RE: **Pinnacle Bellevue North**
Project #: 21-103195-LD; 21-103192-LP
Revision Request #5

The Development Review Committee (DRC) has reviewed the plans submitted on September 14, 2023 for the Administrative Design Review, file number 21-103195-LD and Master Development Plan, file number 21-103192-LP. Below are additional comments and revision requests from the City's review team. **Please note that additional information may be requested as a result of our review of your resubmittal.**

Green and Sustainability Factor

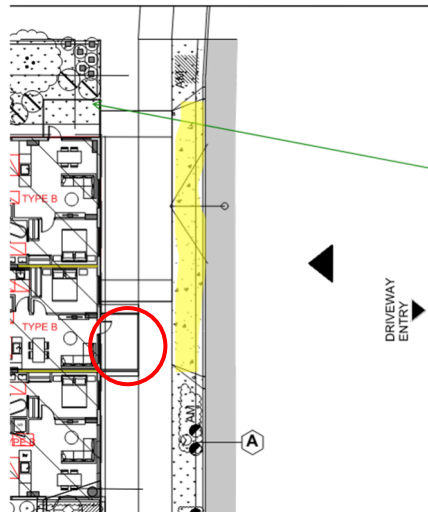
1. Provide the calculations for each Landscape Element, Green Roof, Green Walls, Landscape Bonuses and Publicly Accessible Bicycle Parking. Provide a Landscape Plan to show location and areas in square feet for all elements you proposed to meet the Green and Sustainability Factor. See Sheet LA-404 for additional review comments.
2. If you want credit for Publicly Accessible Bicycle Parking (bike racks) in the Green and Sustainability Factor, you must show the bike racks on all the Landscape Plans and Site Plan drawings.
